VIGIL and Kysor VIP Lightbar Turn Signal Wiring

54-26

**Freightliner
Service Bulletin**

Fig. 1

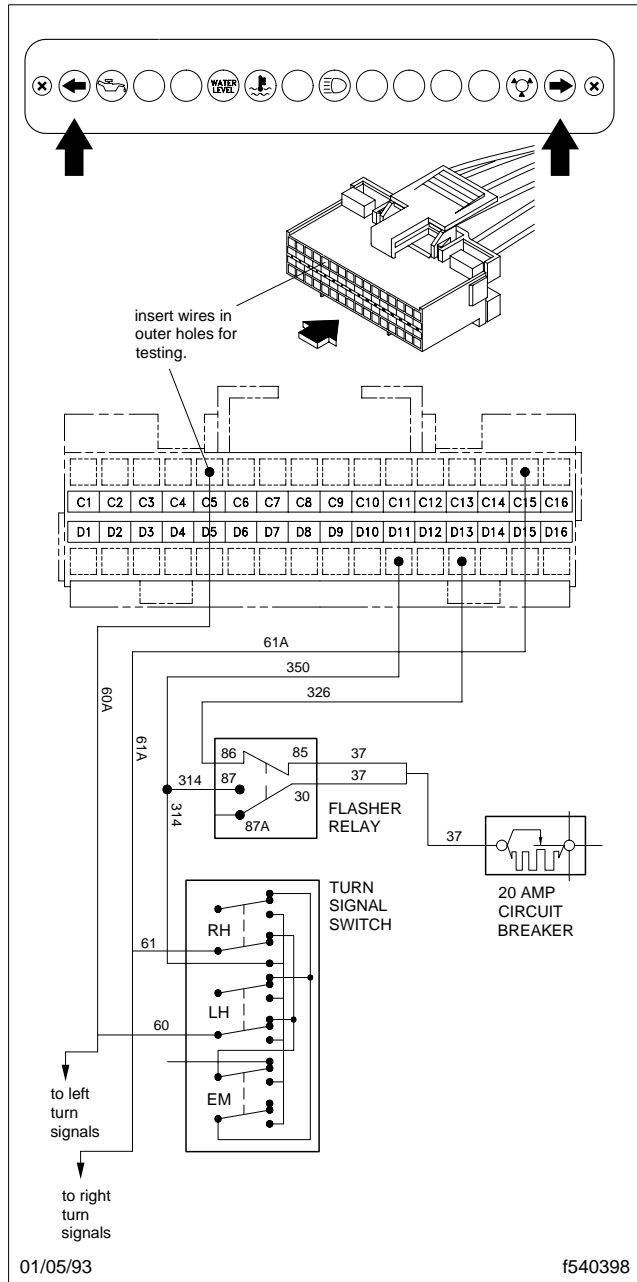
The turn signal system functions as follows (see Fig. 1). The turn signal sensing/timing is controlled by the VIGIL or Kysor VIP lightbar. Whenever the turn signal switch is actuated, wire 60 (left turn) or 61 (right turn) is connected to wire 314/350. When the lightbar senses this ground path through wire 350, it starts its turn signal timing circuit by grounding wire 326. When wire 326 is grounded, power is sent through the flasher relay (wire 314) to the turn signal switch and out to the turn signal lamps. This continues until the turn signal switch is released.

If the lightbar is the cause of inoperative turn signals, the affected circuit can now be repaired without replacing the lightbar.

Fig. 2

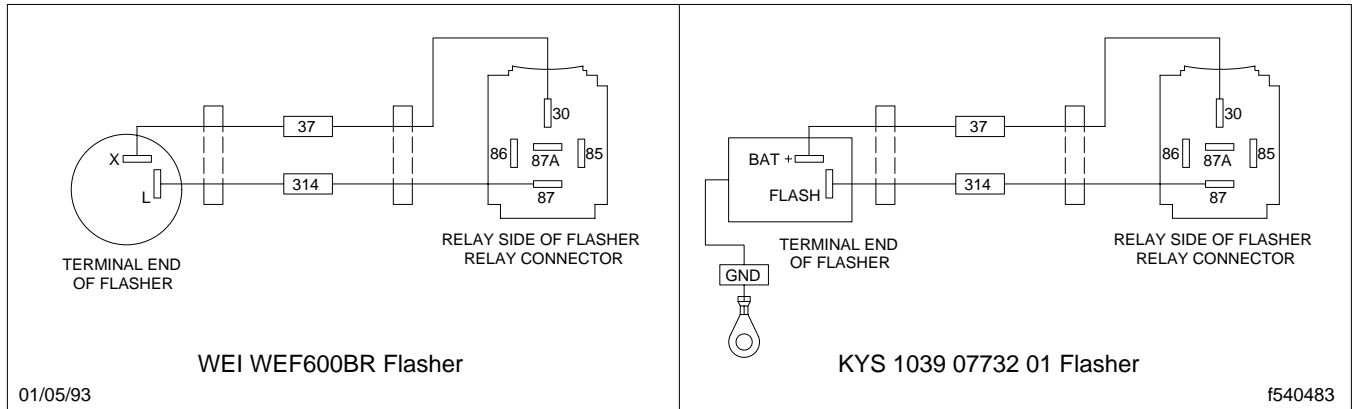
1. Remove the existing flasher relay, BSH 0 332 204 132 from the vehicle electrical panel. The relay panel should be marked "flasher."
2. Install the male terminals of the jumper harness into the flasher relay connector as shown in Fig. 2. Install wire 314 into terminal 87 of the flasher connector. Install wire 37 into terminal 30 of the flasher connector.
3. Install the new solid state flasher at or near the electrical mounting plate.

4. For the WEI WEF600BR flasher:
 - 4.1 Connect the female terminal of wire 314 to the flasher's male terminal marked "L."
 - 4.2 Connect the female terminal of wire 37 to the flasher's male terminal marked "X."
5. For the KYS 1039 07732 01 flasher:
 - 5.1 Connect the female terminal of wire 314 to the flasher's male terminal marked "FLASH."
 - 5.2 Connect the female terminal of wire 37 to the flasher's male terminal marked "BAT +."
 - 5.3 Connect the flasher ring terminal of the flasher "GND" wire to the flasher mounting bolt.
